18 May 1960

- B. 1. At/several points in the text of this report, reference is made to the bandwidth of the ASR-1 placing a limitation on the allowable deviation of the RT-3R. It is felt that if the BT-3R deviation is set as suggested in the RT-3R operation manual, the input from an operational migrophome installation would have insufficient amplitude to cause the transmitter deviation to exceed the bandwidth of the ASR-1.

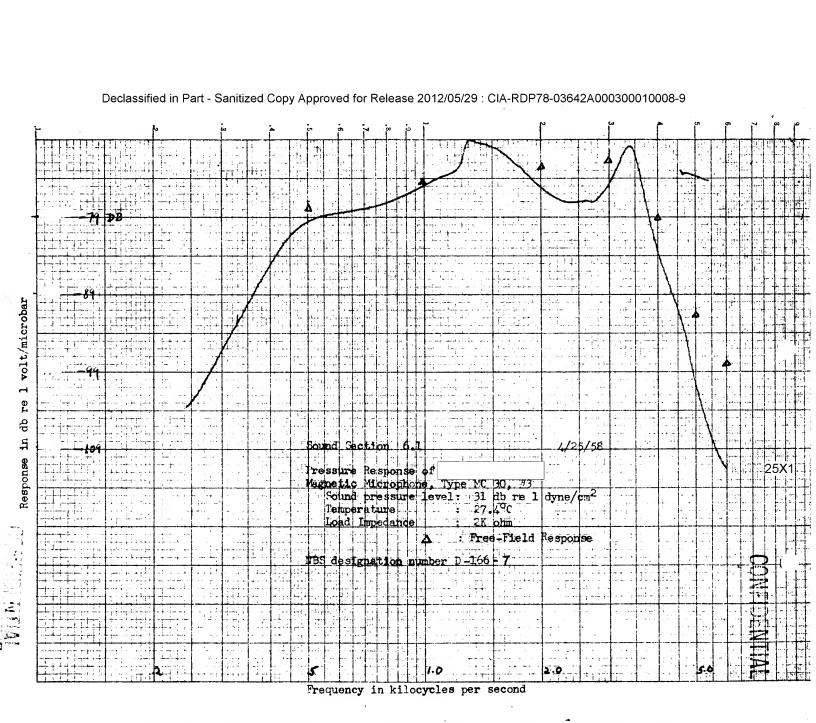
EXAMPLE: BK-6B CURVE WITHOUT

RESPONSE = - 86 db max

AMPLITUDE OF MIC OUTPUT IS CALCULATED

VOICE PRES. = - 3 db re 1 dyne (74-71)

E = -86+(-3) = -89 db re 1 VOLT

$E = 10 - \frac{(89)}{(1 \text{ V.})} = 10 = 35.4 \text{ MV.}$

Audio Frequency Response For Two Microphones & Two Receivers db Receiver -20 0 Min.) Audio Audio Max.) Control -10: Setting đЪ -20 -30 **/10** 0 db -10 BK-6B Microphone -20 ø **≠10**, 0 dЪ -10 -20 10 100 1000 10000 Frequency (cps) CONFIDENTIAL

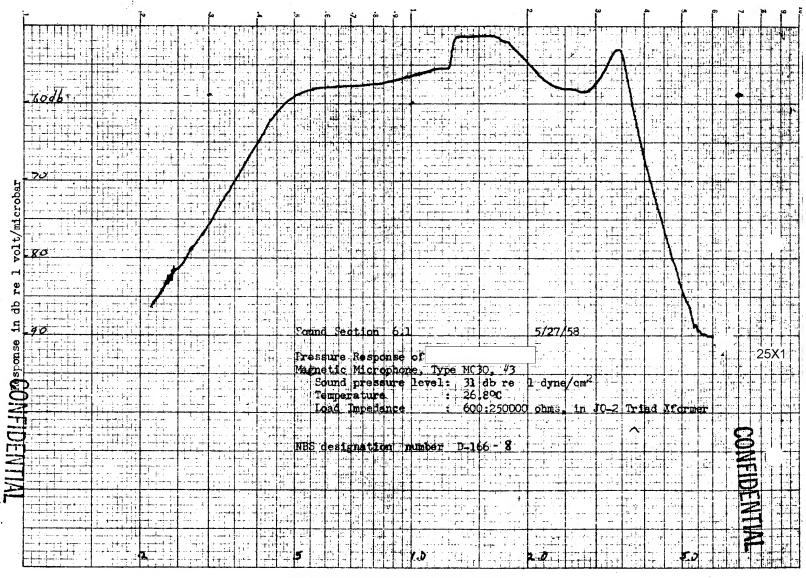
- 3. The frequency response viewed at the "AUDIO P.A." jack drops $\frac{400}{1000}$ off very rapidly at frequencies below $\frac{1000}{1000}$ cps, while at the "AUDIO DET." jack it remains essentially constant from 50-1000 cps. The response above 1000 cps drops off at approximately the same rate for both jacks.
